FINAL
AS-BUILT BASELINE
MONITORING REPORT
MUD LICK CREEK MITIGATION SITE
Chatham County, North Carolina

NCDMS Project No. 93482
Contract No. 7683
USACE Action ID No. SAW-2014-00736 & DWR Project No 2014-1127
SCO No. 1209857-01
Data Collection: July 2018
Submission: September 2018

SUBJECT: Amendment to Approved Mitigation Plan
Mud Lick Creek – DMS #93482
Cape Fear 03030003; Chatham County

Title:
CURRENT CONDITIONS PLAN VIEW

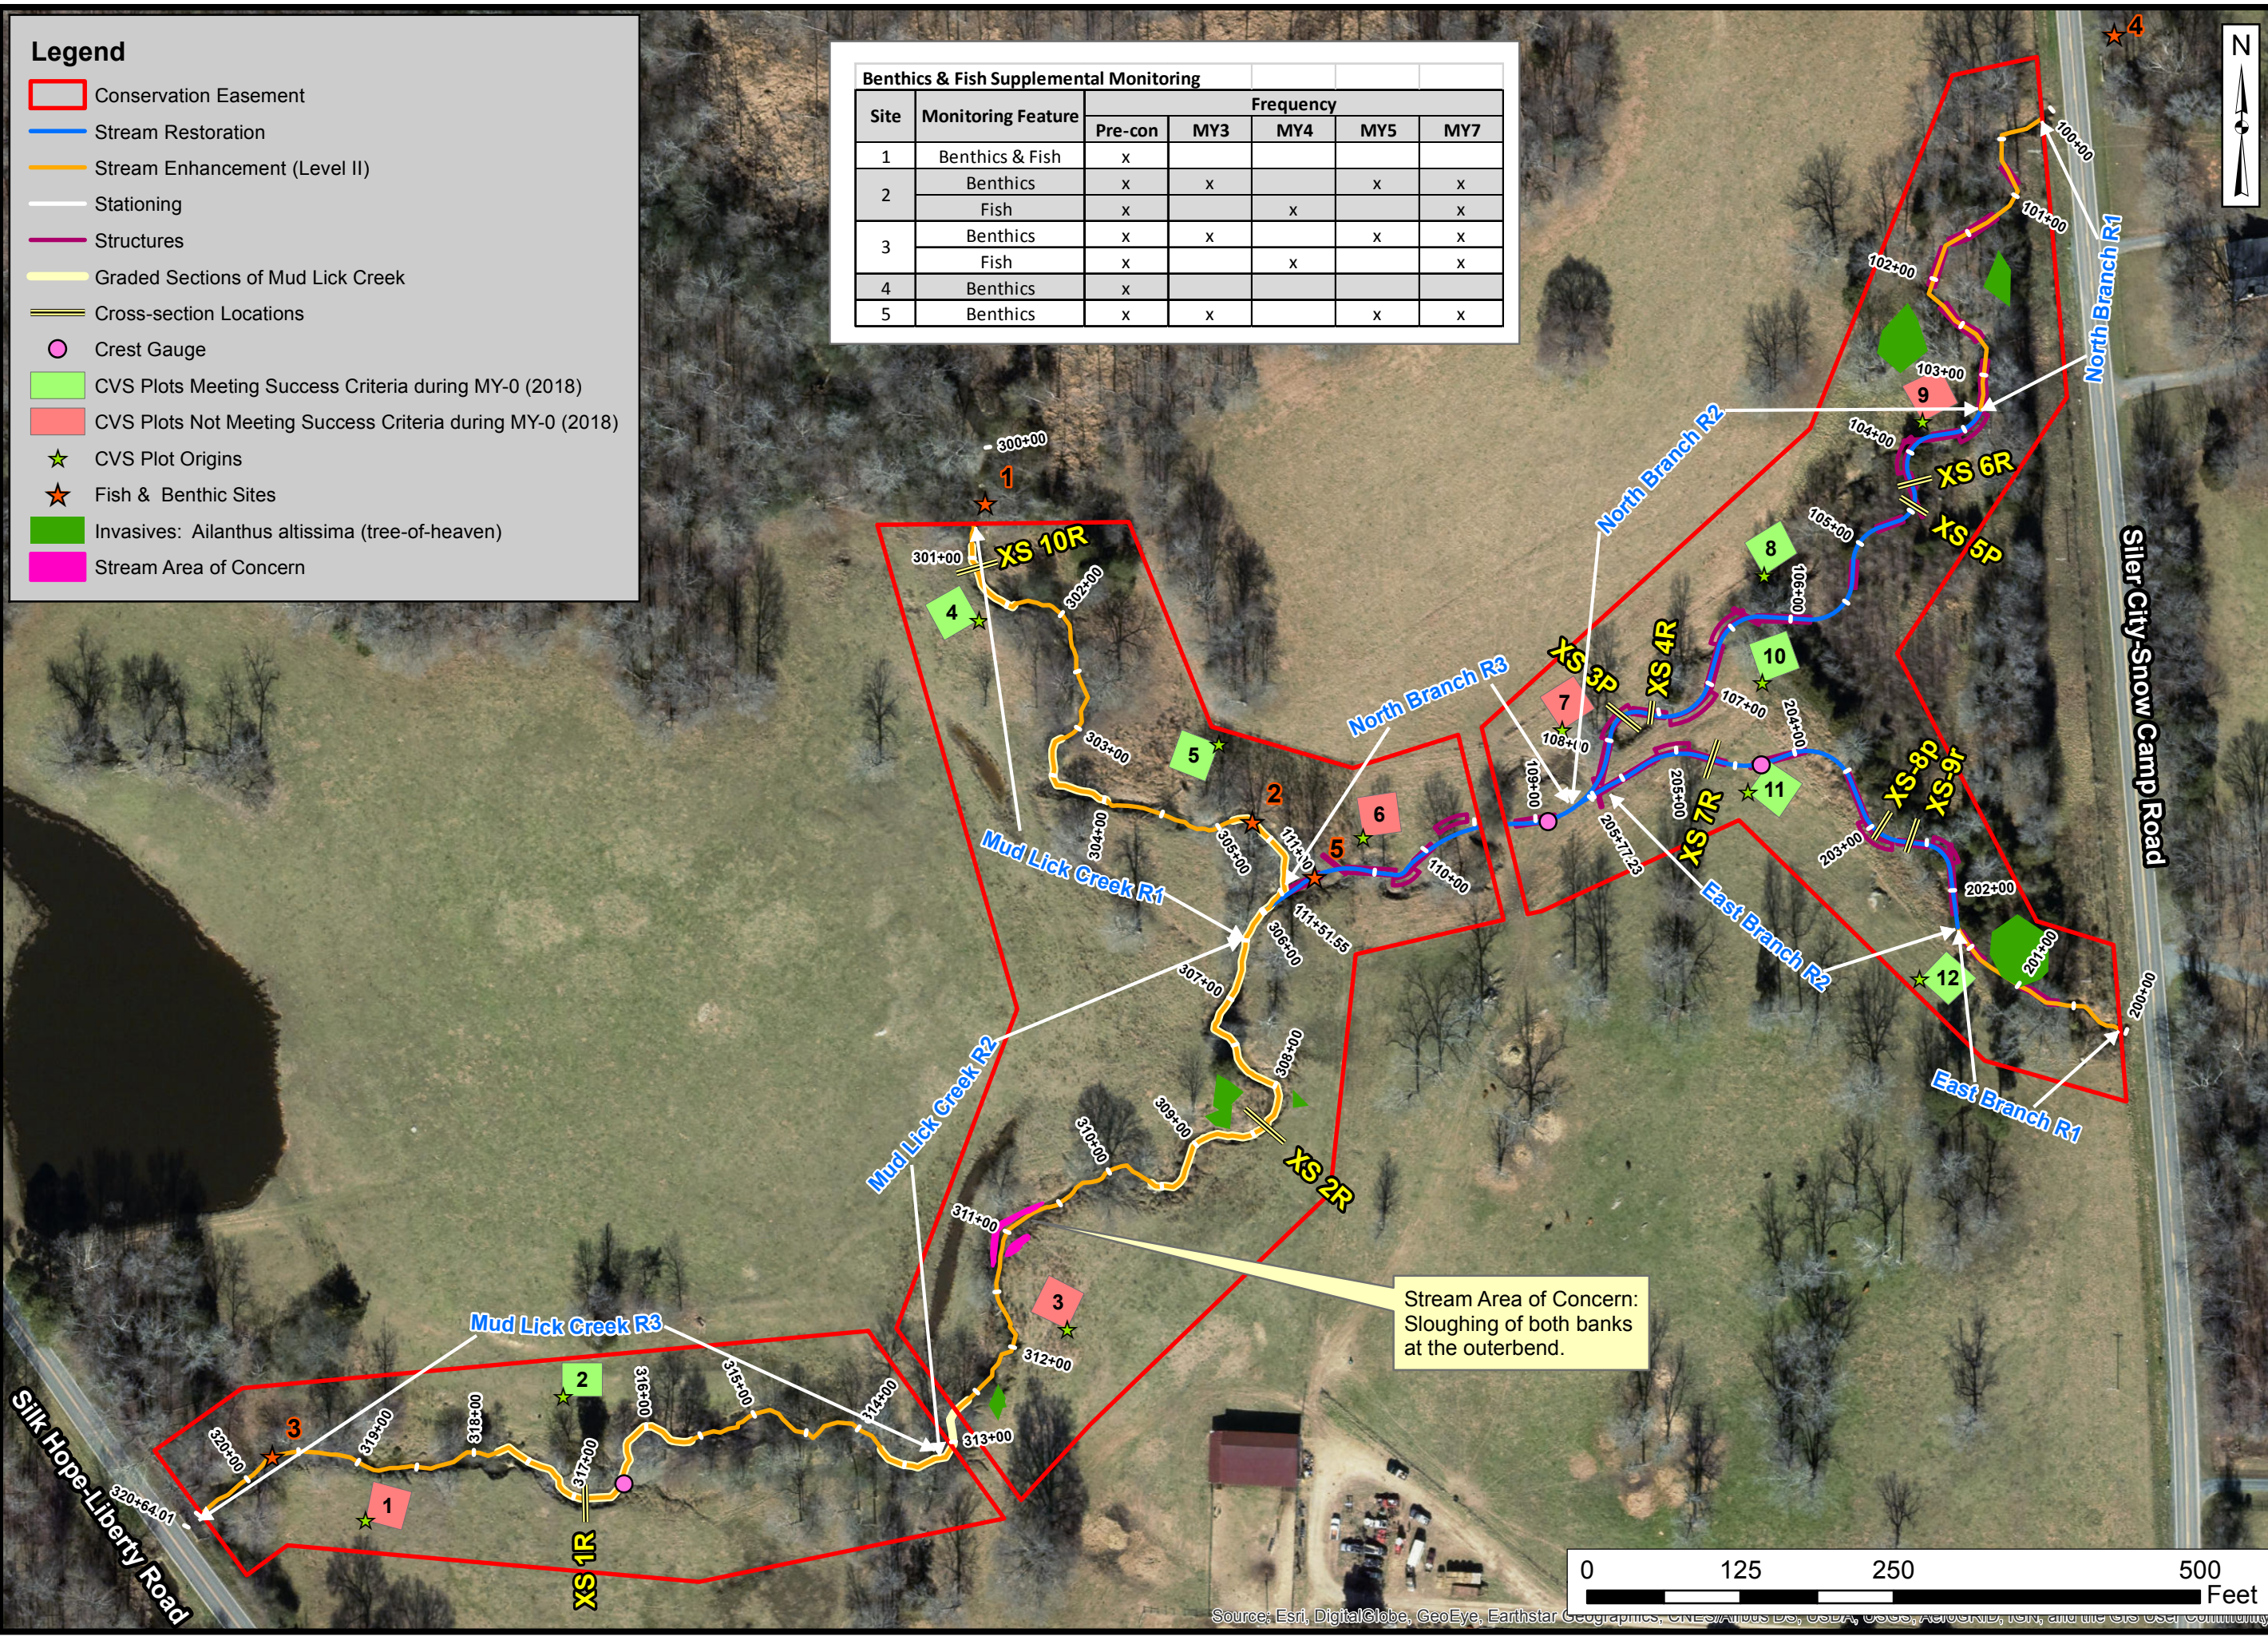
8. Appendix B, Figure 2:

- a. Please identify all reaches as named in Table 1. *All reaches were labeled on the figure to match Table 1.*
- b. Please show locations of the three crest gauges installed at the site. Also make sure that these are included in the digital/GIS files (see comment 1.c. above). *These have been added to Figure 2 and the shapefiles are included in the digital submittal.*

- d. A stream area of concern is shown on Mud Lick Creek Reach 2, but there are no photographs as described in the Project Boundaries & Visual Assessments section on page 2. *Unfortunately, a photograph of the stream area of concern could not be found. A brief description of the area was added to the Stream discussion on page 1 of the report. Photographs of all areas of concern will be provided during all subsequent monitoring years.*

- e. Please symbolize the sections of Mud Lick mainstem that were graded *A layer was added to show the sections of Mud Lick Creek that were graded.*

River Basin:	Cape Fear
Site Name	Mud Lick Creek
XS ID	XS - 10, Riffle (Mud Lick Cr)
Drainage Area (sq mi):	3.64
Date:	7/25/2018
Field Crew:	Perkinson, Smith

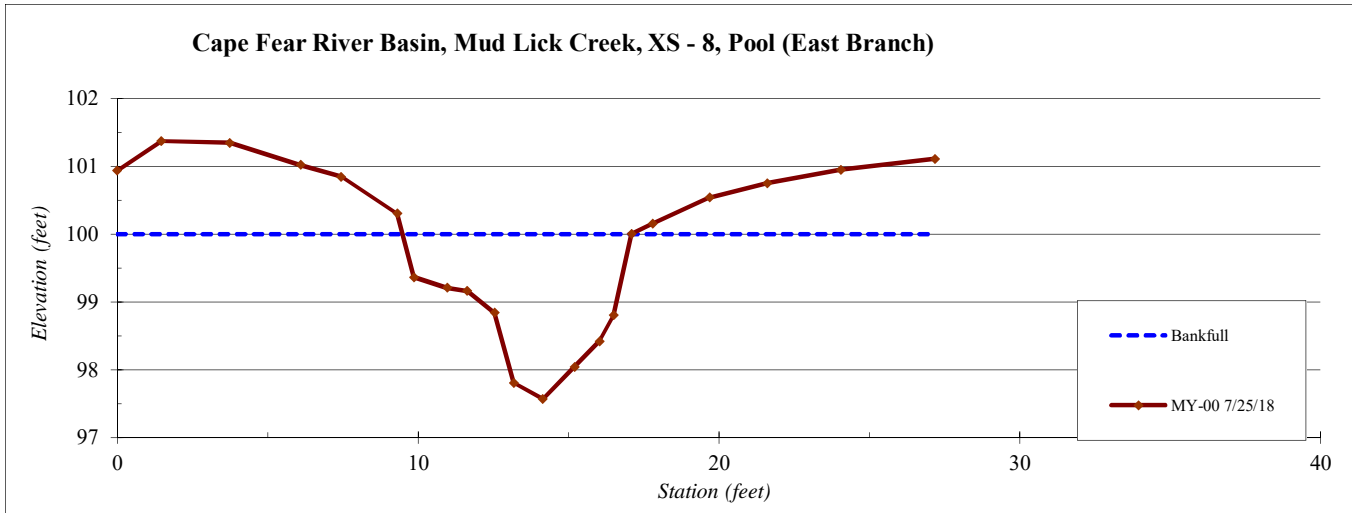
XS 10 seems to be outright incorrect for its XSA calculation. *This was incorrect; the correct data was input and updated throughout.*

Planting Plan

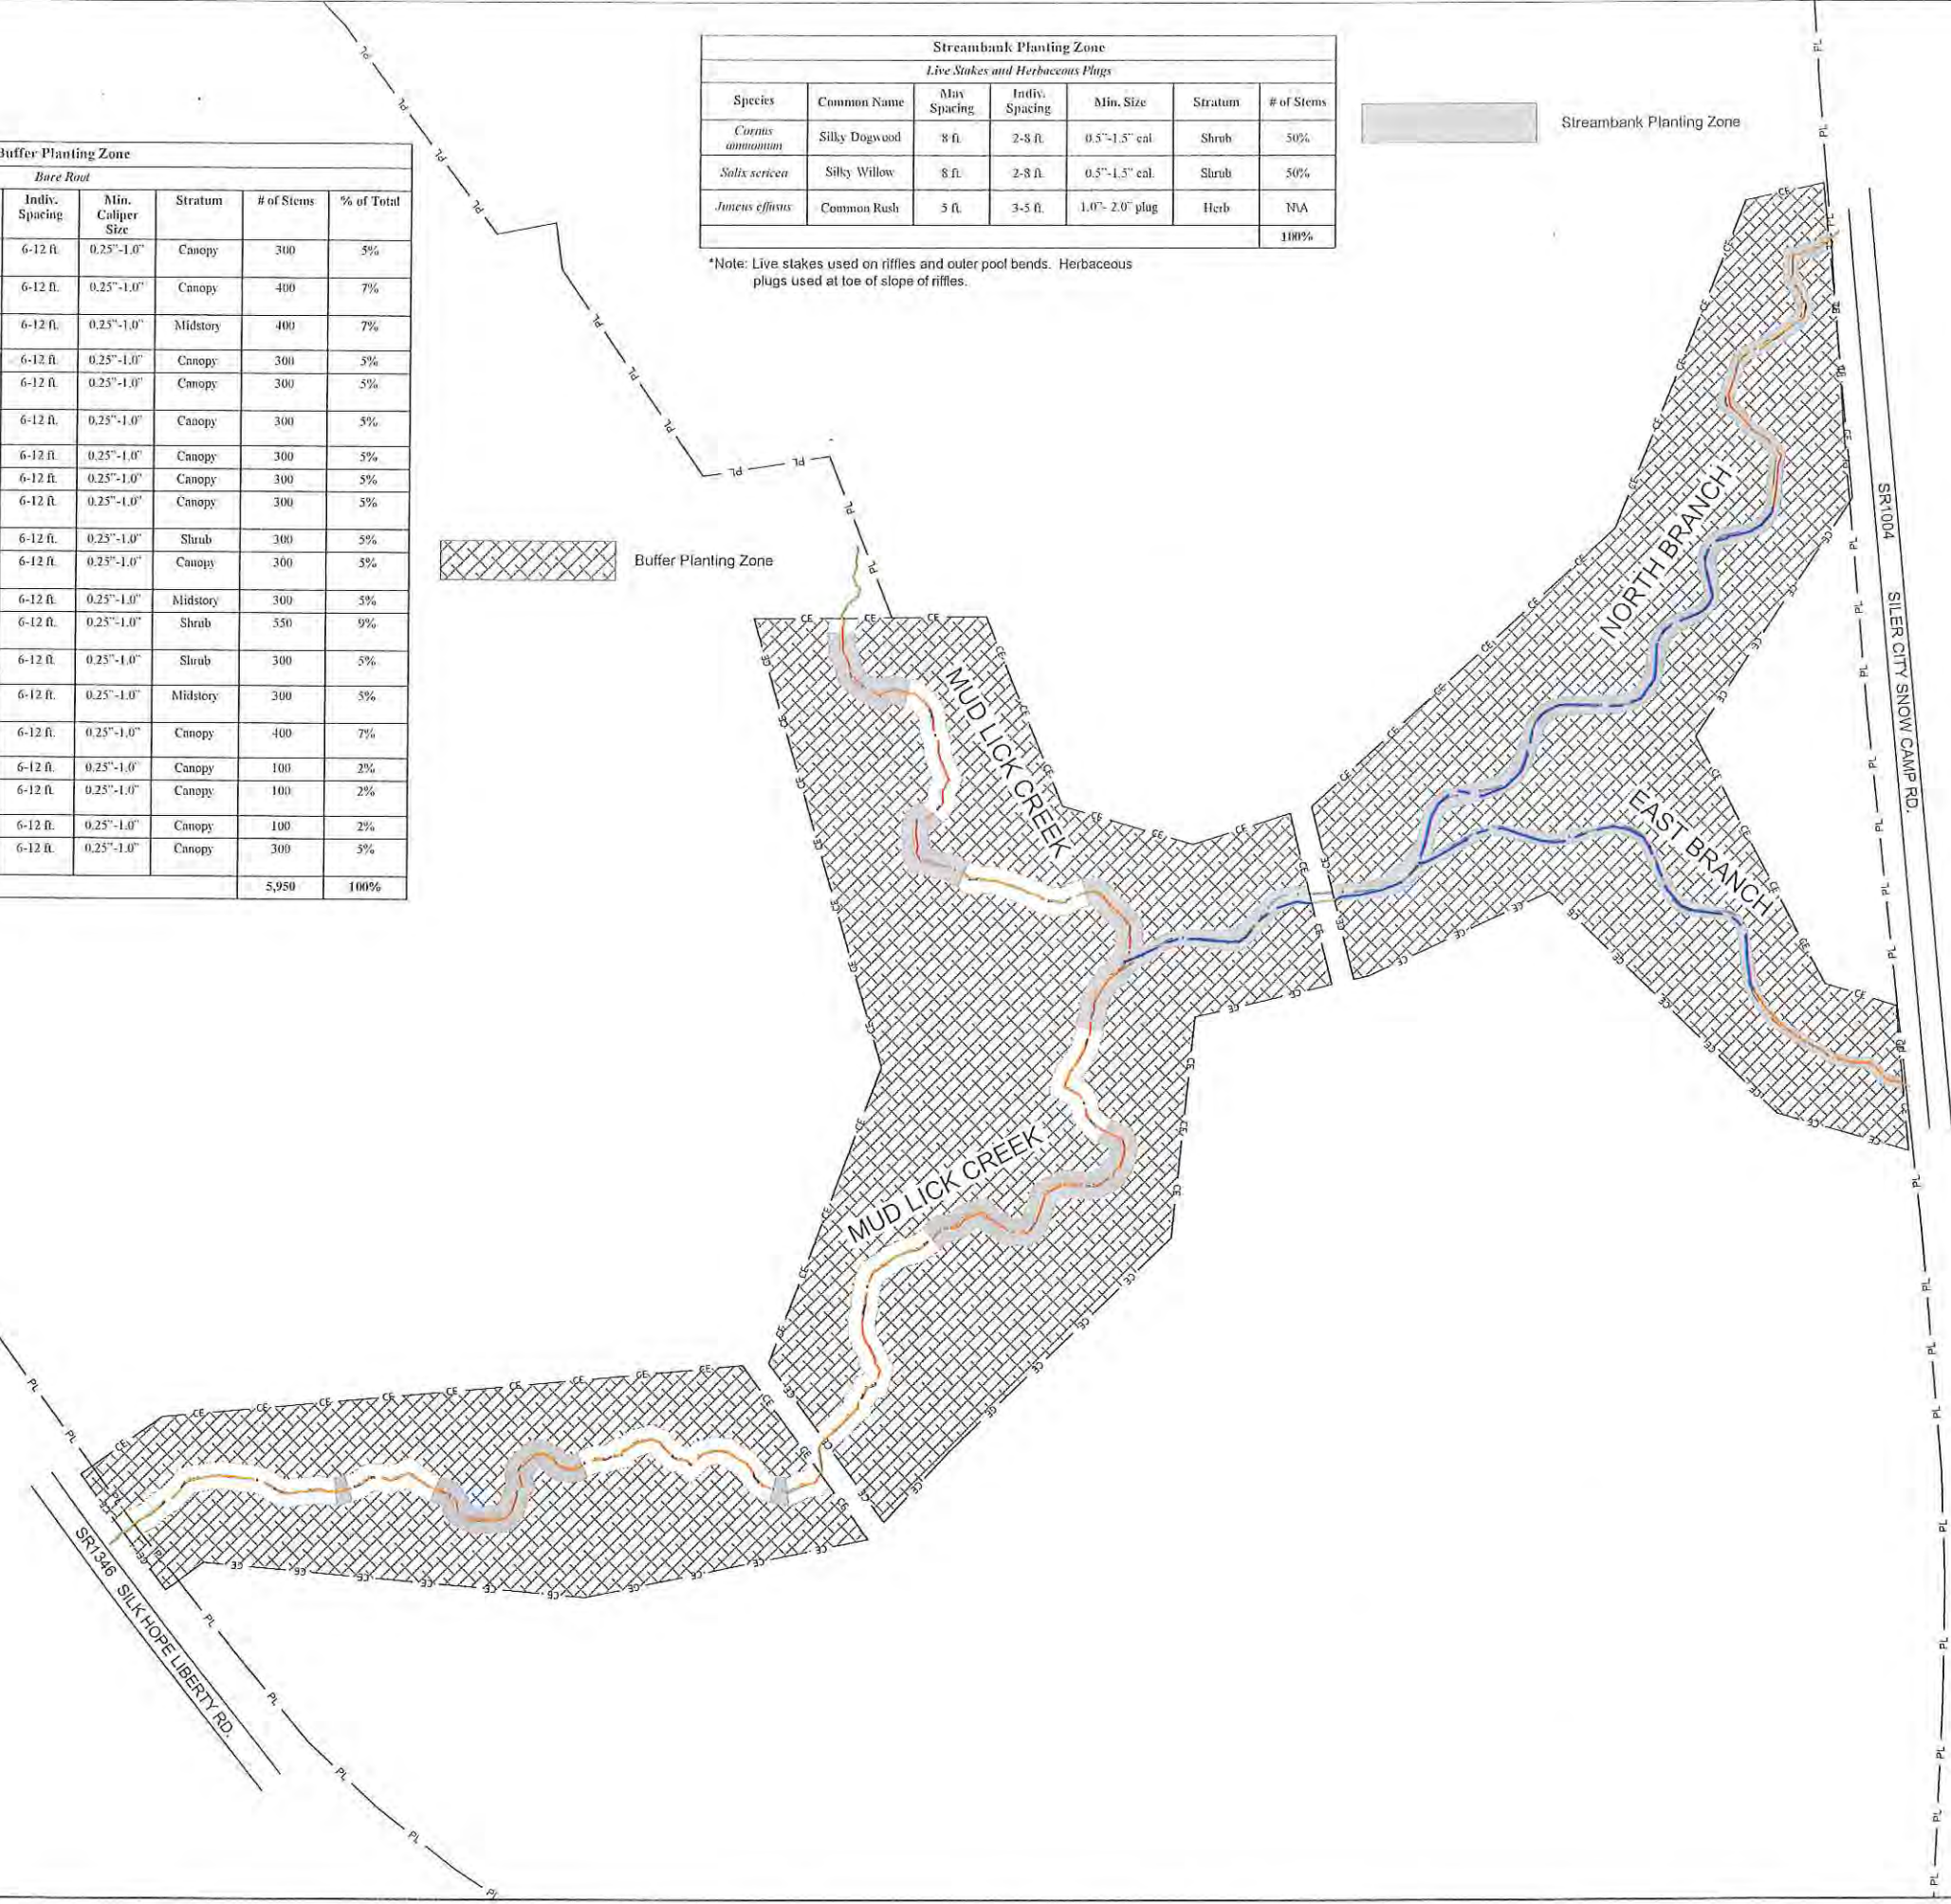
- a. Verify this list against the list on sheet 2.1 of the Record Drawings (see next to last page in Appendix E). There appear to be some differences between the two. *The list was verified to be the same; however, the order of the species listed was different so it was reordered to match the record drawings order.*
- b. Correct spelling for Eastern Hophornbeam. *This was corrected.*

Revisions: Buffer planting species list was revised to reflect as-built conditions.
